SERVICE BULLETIN

PRODUCT RECALL: TIPS™ FUEL CAP

All Go-Karts equipped with TIPS™ cap system.

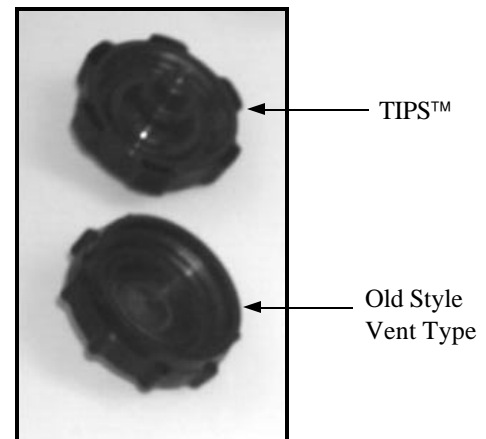
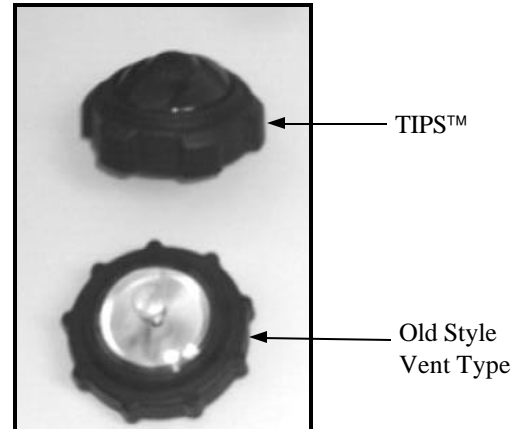
The fuel cap develops a leak during operation. Fuel spurts straight up (1 to 2 inches) from center vent hole. The spillage gets worse when temperature increases.

The new style TIPS™ cap is design to prevent spillage if kart is turned upside down. It does this job very well, but when operated under normal conditions, fuel is forced into cap from movement of kart around track. When fuel gets inside cap, fuel stays in and the only place for it to go is out

Replace TIPS™ cap with old version type fuel cap.
Return defective caps when you receive new ones.

TIPS™: **Part#01080**

Old Style Kelch Cap: **Part#01081**
